**Draft Final Basis of Design Report**

Willow Creek Royes Dam Fish Passage Restoration  
Union County, Oregon

Appendix G. Bonneville Power Administration 30 Percent Submittal Comment Response

## HIP Project Review Comment Tracking

ROYES DAM FISH PASSAGE RESTORATION  
 SUMMERVILLE, OREGON  
**PUMP 4 TEMPORARY WATER MANAGEMENT PLAN  
 AND INTAKE UPGRADE**

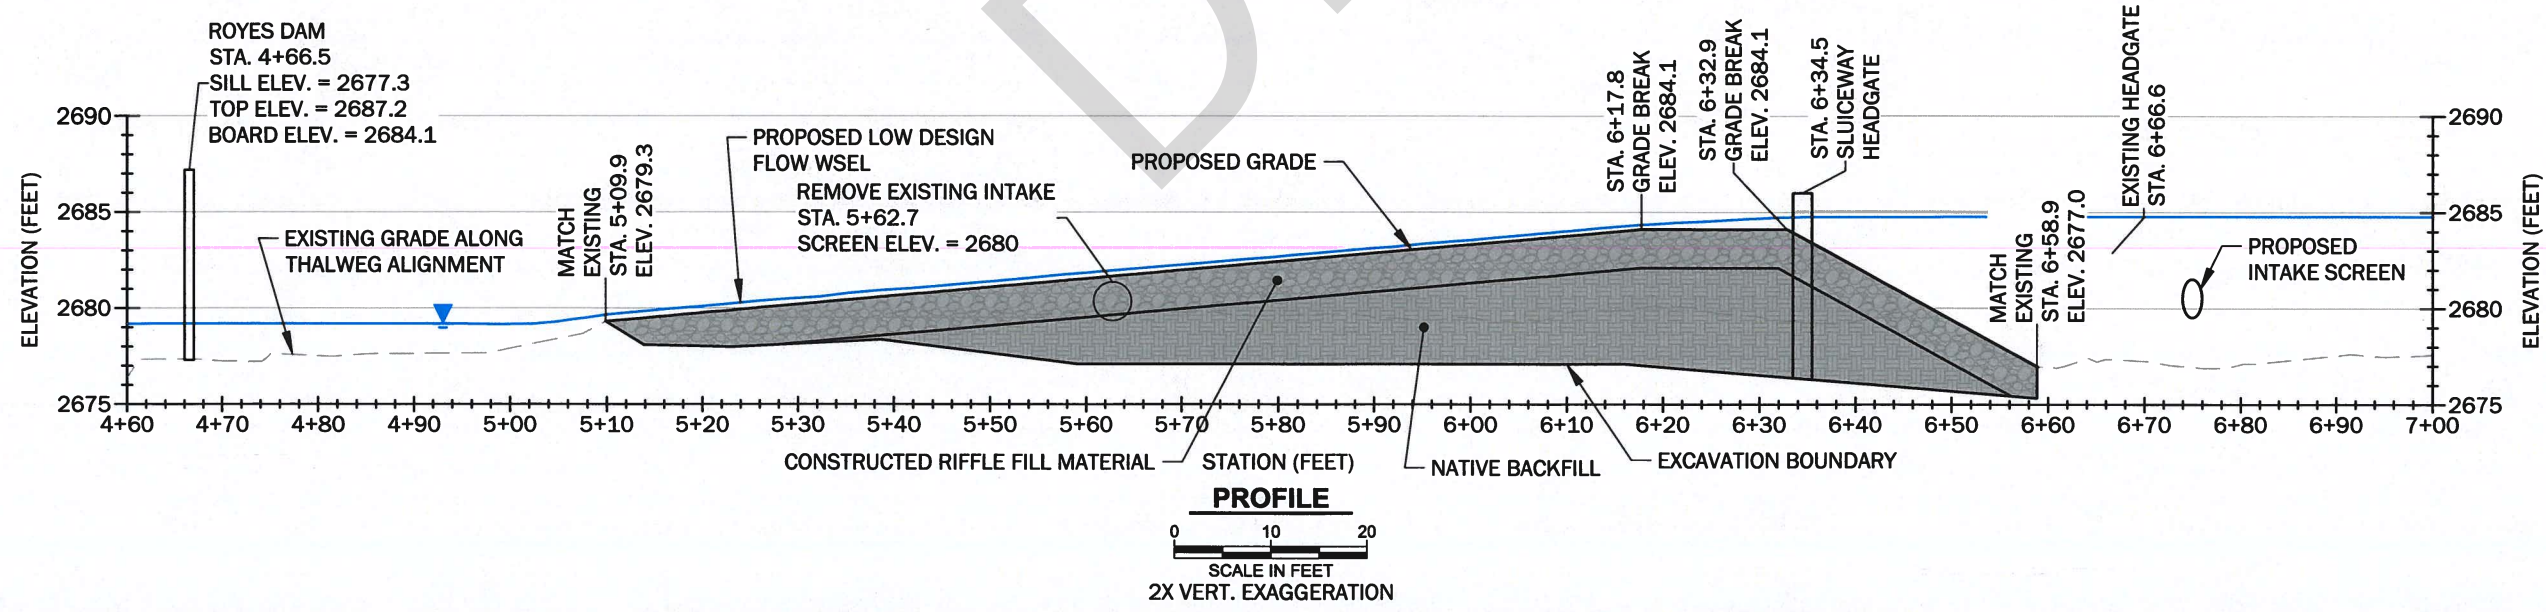
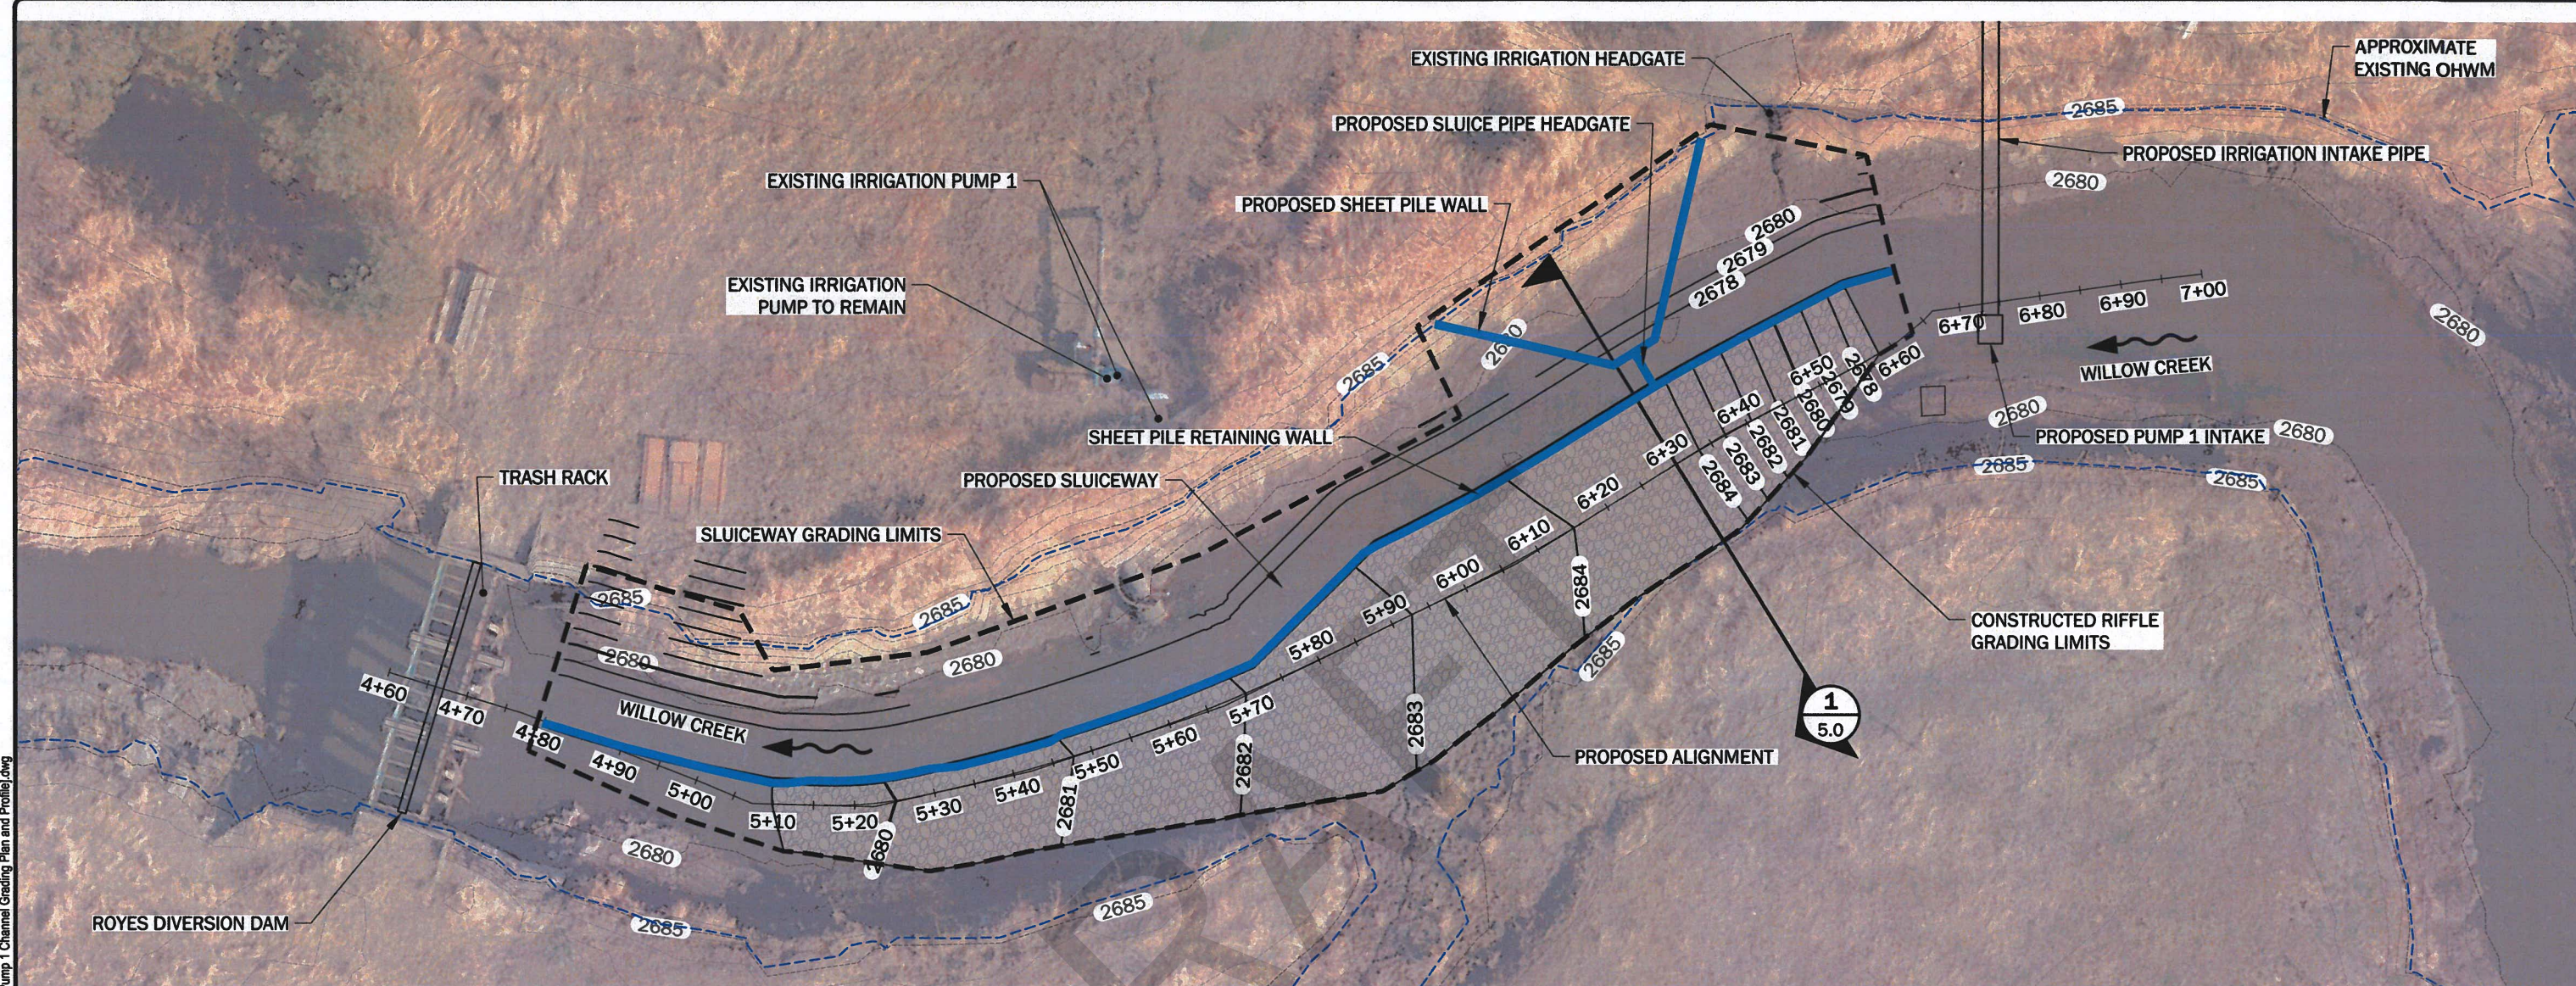
21	ETS	6/7/2023	30% Plans		There are inconsistencies in the presented low flow pool elevations at pump 4 (please check all locations) Page 23 of BDR LFP = 2684.4, Sheet 4.4 LFP = 2683.6, Table 8 BDR LFP = 2683.5. Per comment above, please provide all of these corrected elevations on the project profiles.	GeoEngineers	June 30, 2023	The updated design drawings reflect hydraulic model results for the high fish passage flow and low fish passage flow.	
22	ETS	6/7/2023	30% Plans		The hydraulic sections in the appendix only show 3 feet of depth at pump 4, the BDR identifies a 4 foot depth as criteria.	GeoEngineers	June 30, 2023	The updated BDR reflects water surface elevations representative of the heightened constructed riffle design. This error has been corrected on the draft final design drawings.
